# Minimum Following Distance to the front

**ACSF IWG 23<sup>rd</sup> session on July 2019, Brussels**

Korea Automobile Testing & Research Institute

# Comment History

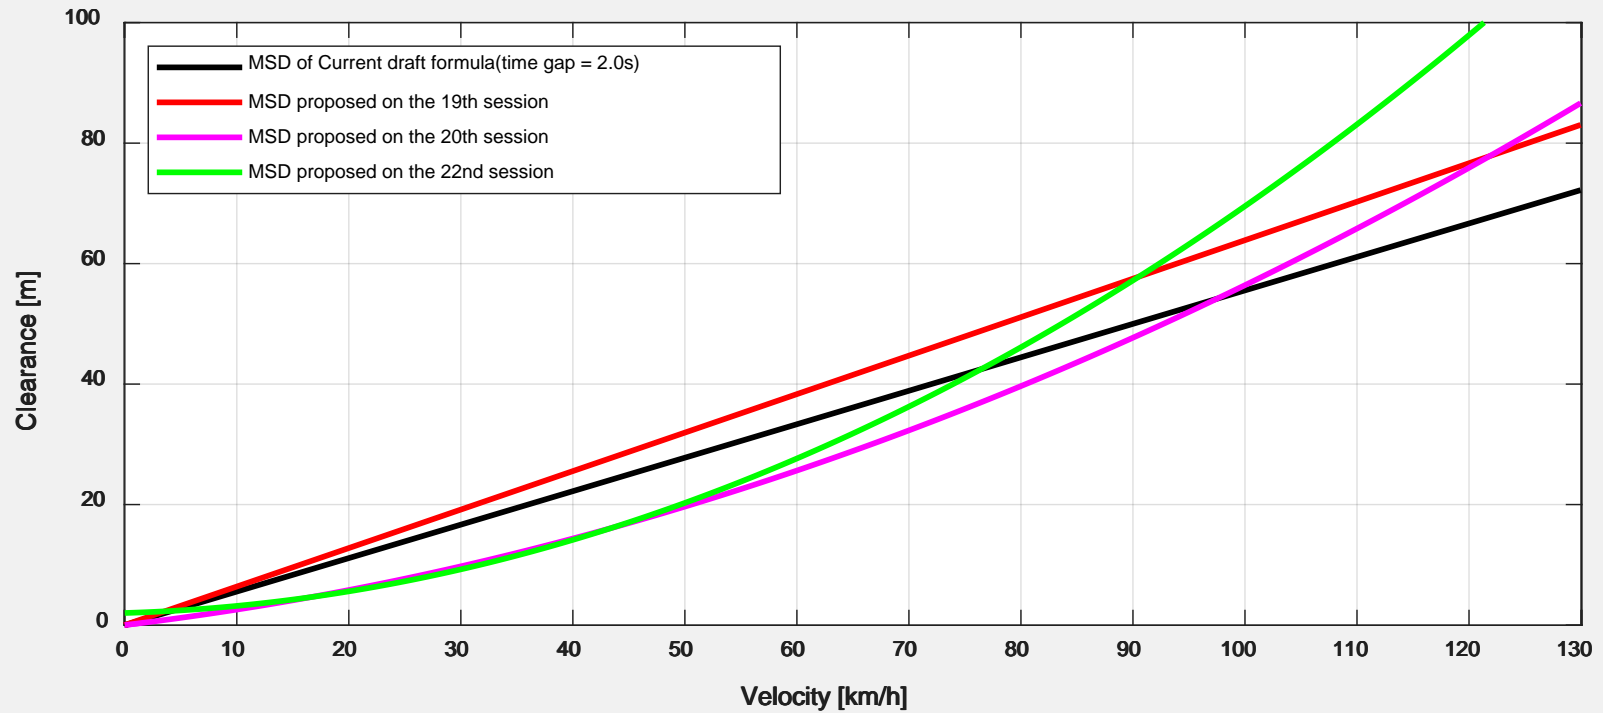
➤ **19<sup>th</sup> session proposal**(ACSF-19-06) :  $S = V_{ALKS} \times t_{front}$ ,  $t_{front} = 2.3\text{sec}$

- comment : concern for frequent occurrence of cutting-in in low speed range

➤ **20<sup>th</sup> session proposal**(ACSF-20-08) :  $S = V_{ALKS} \times t_{front}$ ,  $t_{front} = 0.8 + \frac{1.6v_{LKLC}}{36.1}\text{sec}$

- comment : concern for too high deceleration( $9\text{m/s}^2$ )

➤ **22<sup>nd</sup> session proposal**(ACSF-22-09r1) :  $S = V_{ALKS} \times t_{front} + d_s$ ,  $t_{front} = 0.2 + \frac{2.9*V_{ALKS}}{36.1}\text{sec}$

- comment : concern for too long distance at mid and high speed
